VOLUME 5

RECORDS OF SEMINAR AND
MEETING/DISCUSSION

The Project for the Study on Improvement of the Bridges through Disaster Mitigating Measures for Large Scale Earthquakes in the Republic of the Philippines 1st Seminar

Figure-1 Development of DPWH Bridge Seismic Design Specifications

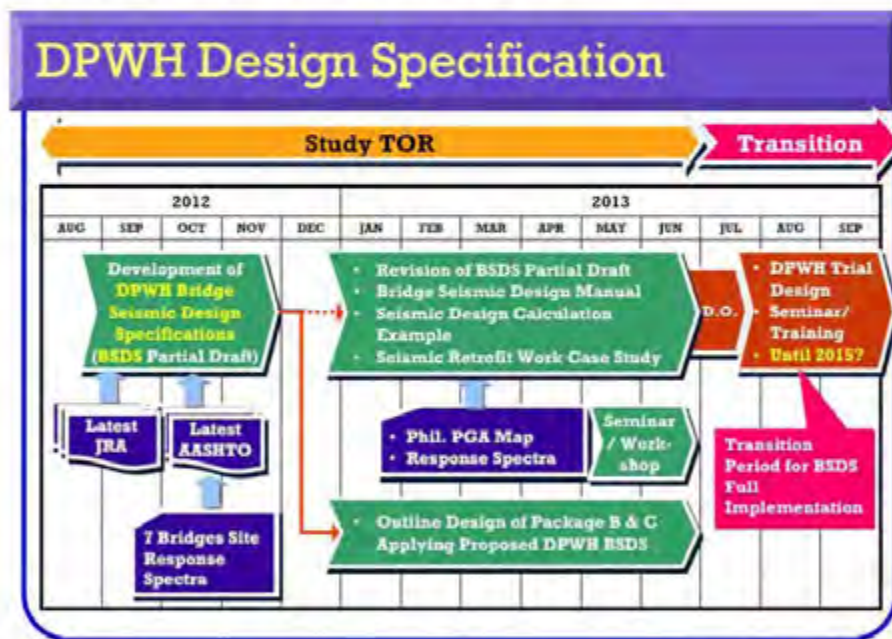
- DPWH Counterparts (hereafter called as DPWH) agreed with the suggested study flow on Development Process of DPWH Bridge Seismic Design Specifications (BSDS) shown in Figure-1.

* Initial draft of the BSDS will be prepared by Dec. 2012 with site specific response spectra for the outline design of seven (7) bridges.
 * Final draft of BSDS including contours of PGA and spectra will be prepared by June 2013.
 * Transition period will be set after the submission of draft BSDS to prepare and orient DPWH for the new BSDS: DPWH will continue with the current design practice based on "AASHTO Standard Specifications for Highway Bridges 17th Ed., 2002" during the period.
